Japan Position for Thermal Runaway Initiation Method

EVS-GTR IWG Apr. 2023

JAPAN AUTOMOBILE STANDARDS INTERNATIONALIZATION CENTER

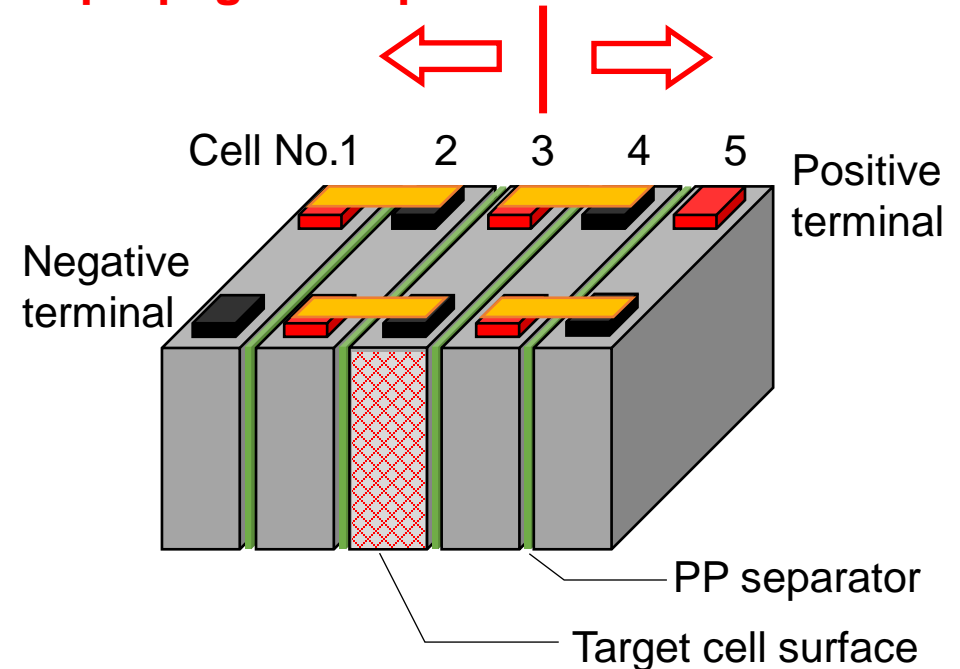
- Japan believes that other methods should be allowed as optional initiation methods, e.g. "nail method".

■ Japan propose to add the following sentence (red text) to the JRC draft

Optional initiation methods.

At the discretion of the manufacturer, any other initiation methods that can cause thermal runaway of the target cell satisfying the conditions specified in paragraph “Detection of thermal runaway” could be selected.

The vehicle/Tested-Device shall be observed for 5 minutes after providing the warning specified in 5. Performance requirements.
